SUBJECT: Coded Objections on Volume 1, Hydrographic Survey
Report, 20 November 1992

COMMENTS FOR STAFF JUDGE ADVOCATE'S OFFICE

Comments on HSR, Nov 1991:

Comments on HSR, 20 Nov 1991, Vols 1-9:

1A Plate 11

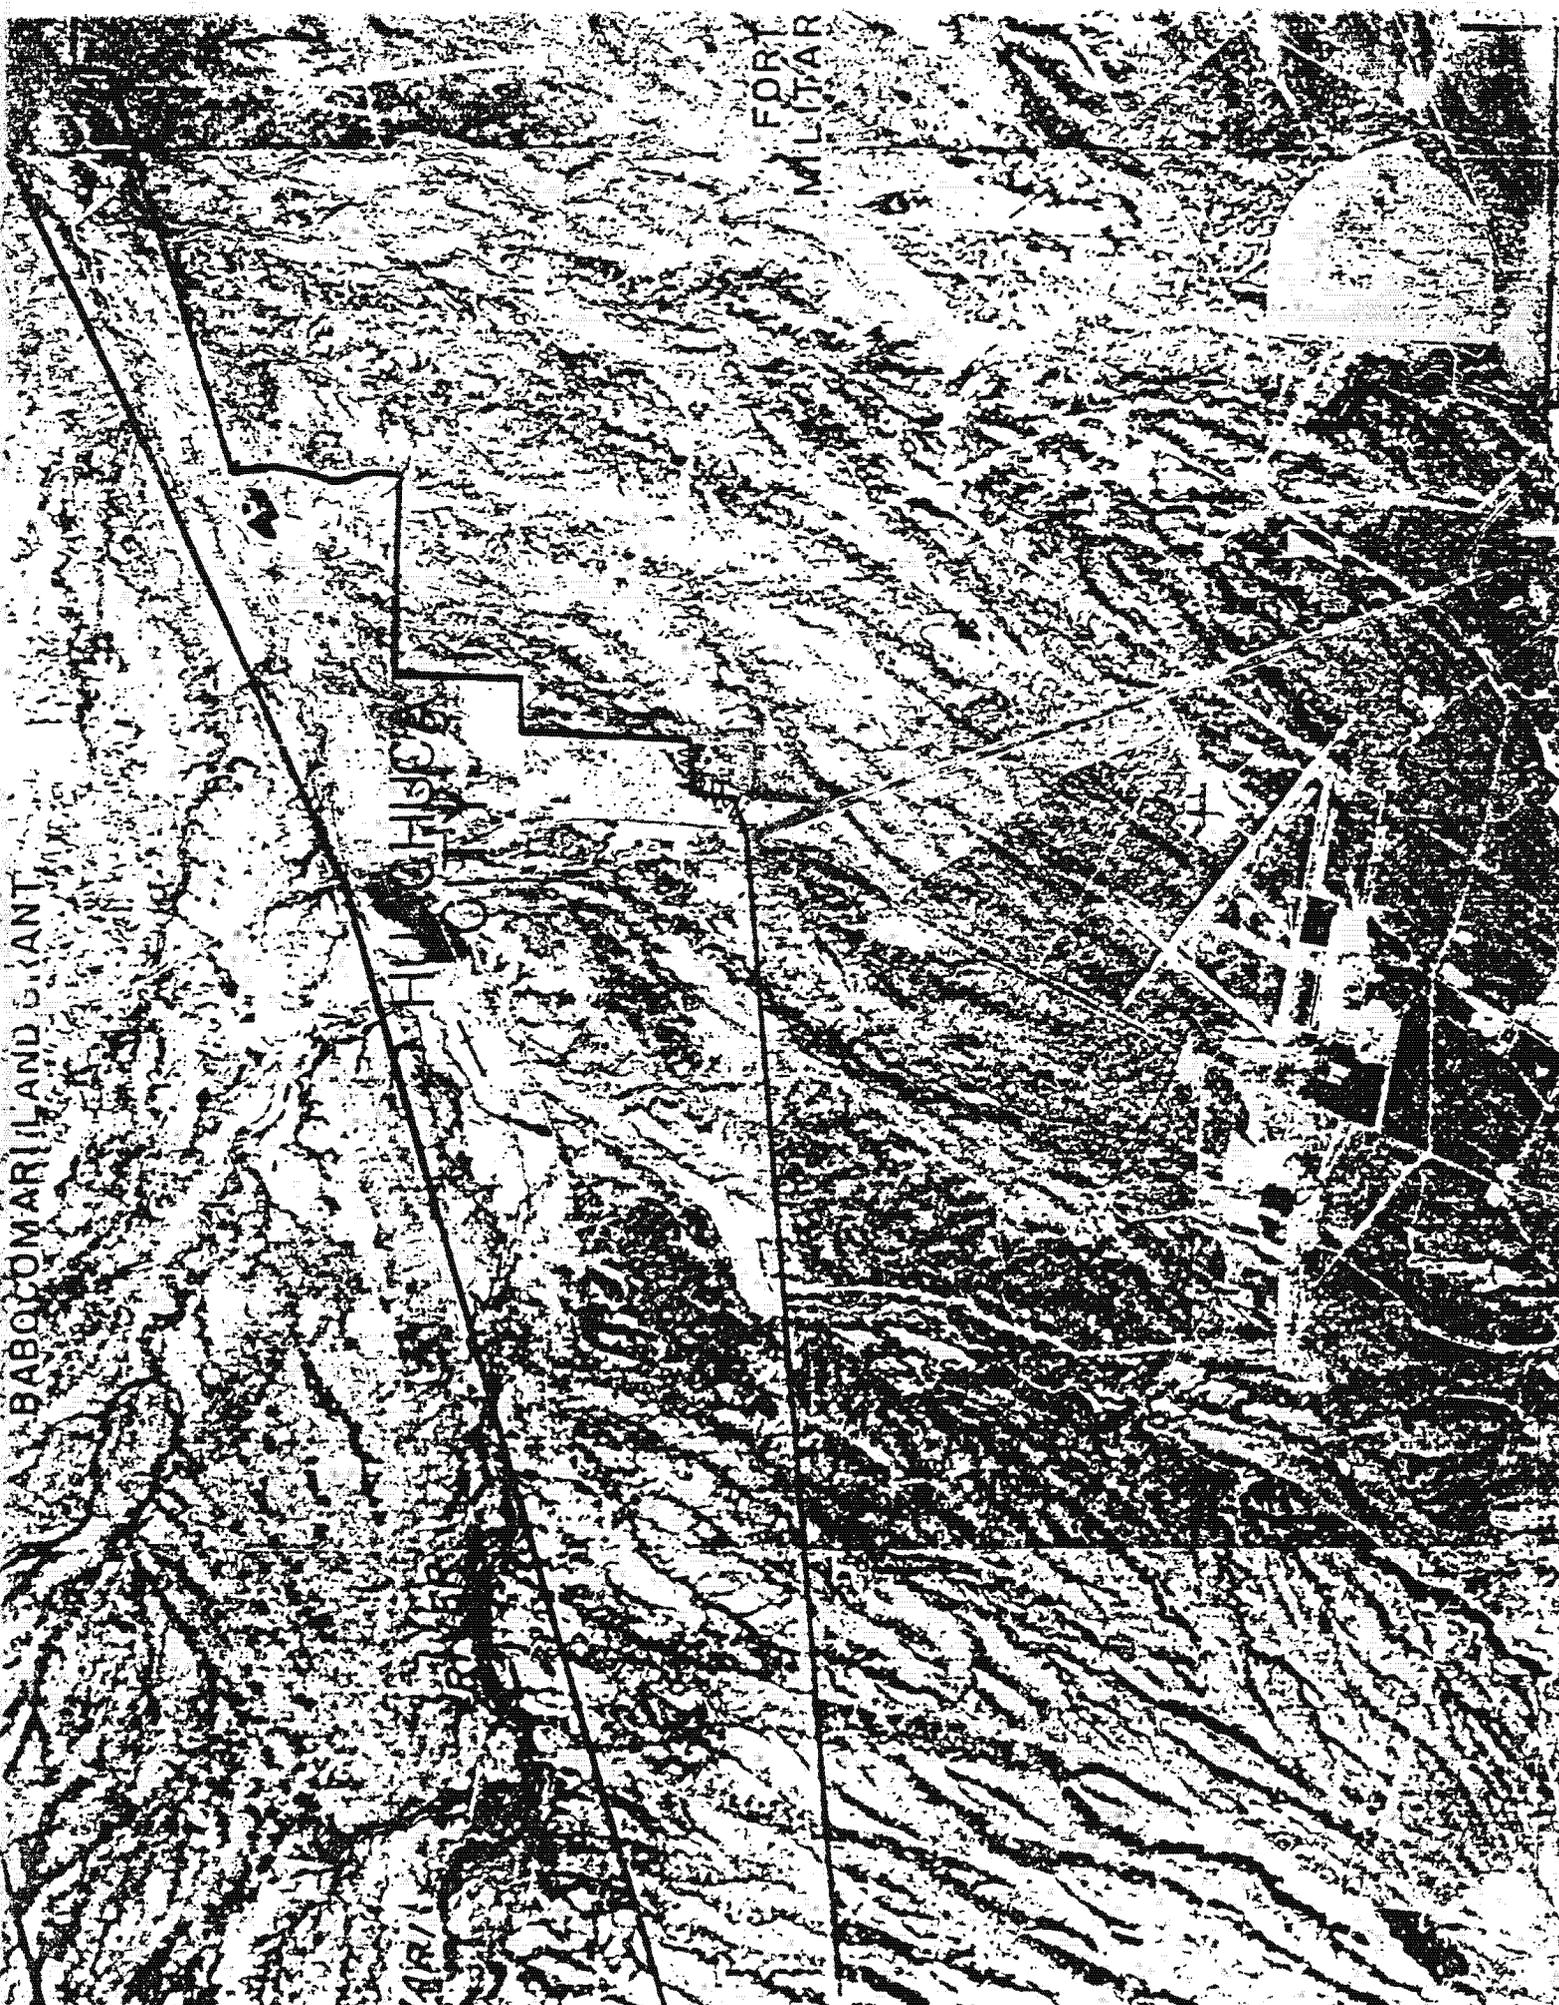
29. Vol 1A, Plate 11, shows fort boundaries just south of Huachuca City at the junction of Huachuca City and Hwy 90 and East/West Reservations incorrectly...

should be
